## **ADDENDUM NO. 2**

**DATE:** October 17, 2023  
**FROM:** City of Grand Junction Purchasing Division  
**TO:** All Offerors  
**RE:** Westlake Park Irrigation Main Line Replacement

**Bid Schedule: Westlake Park Irrigation Main Line Replacement**  
**IFB-5304-23-DD**  
**Addendum No. 2**

**TITLE:** WESTLAKE PARK CONCEPTUAL MASTER PLAN

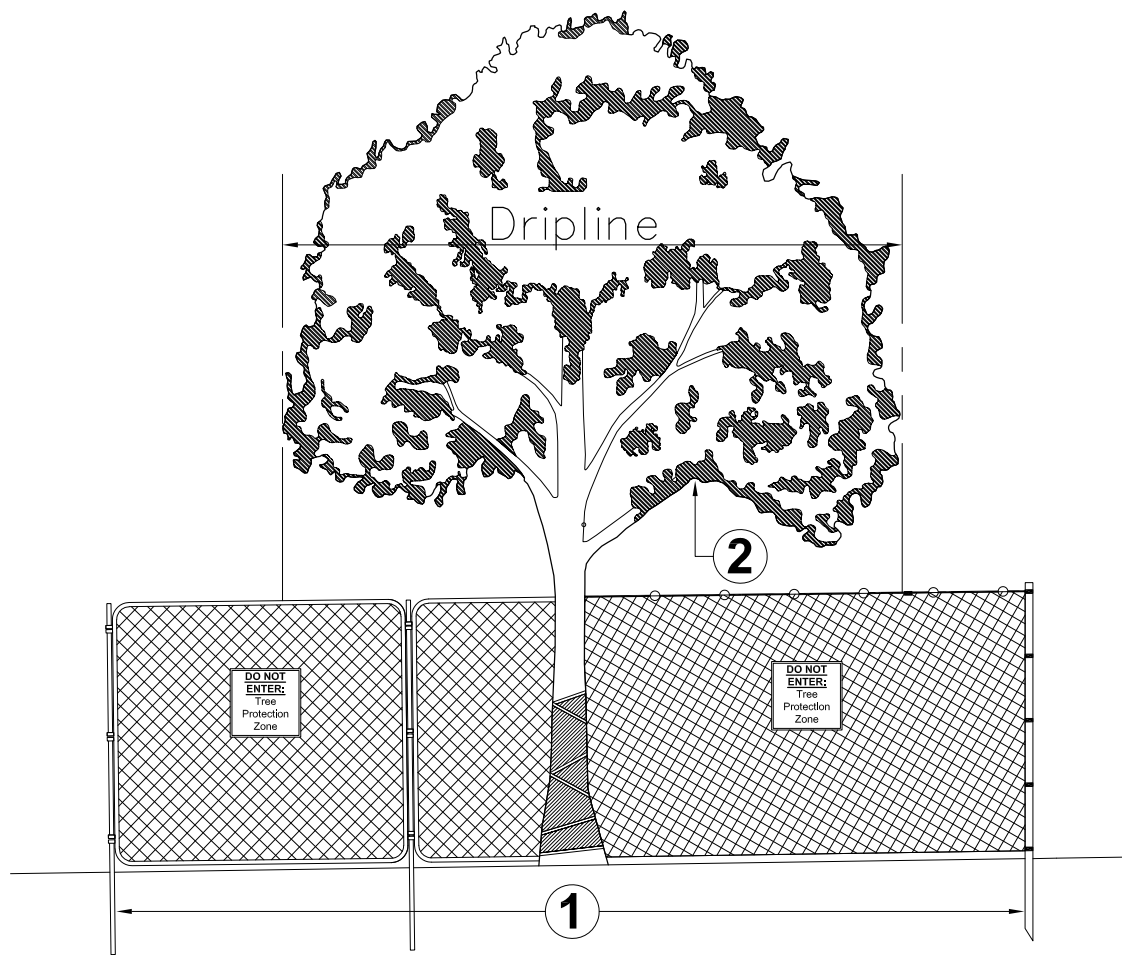
1. **Question:** Was the plan to provide the existing irrigation as built after the bid opening and award?  
**Answer:** See attached.
2. **Question:** there is no explanation in the Scope of Work about how Tree Protection is being handled. We see the Hunter Staking Kit and rebar, so we assume Tree protection is to install these items to water trees during construction. Without a live irrigation system, where are the sources to connect and water the trees during construction. Do we remove these items after the project is completed? Do the trees need fencing around each tree? Mulch around the tree bases during construction?
